COCA-COLA NORTH AMERICA EQUIPMENT BULLETIN... SERVICE

DATE: 10/07/2008 **NUMBER: SERV-245**

SUBJECT: ABS Reed Switch Changes

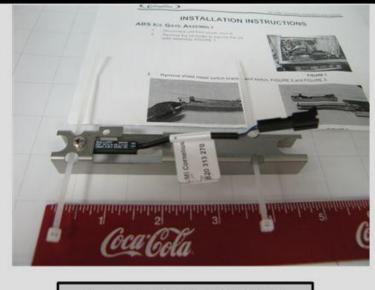
- The mounting of this now includes a bracket that is adjustable
- The adjustment is no longer a 'swivel' type adjustment

The newer bracket is different and has the capability of mounting the new type Balluff switch <u>or</u> the older style reed switch

Once an older ABS (before Serial number 62A0740AB010) has upgraded the bracket portion, only the reed switch will be needed thereafter.

Reed Switch Only - CCP#116386

Lift Assembly Kit - CCP#116390

Ice Gate Kit - CCP#116379

Grabber Block Kit - CCP#116389
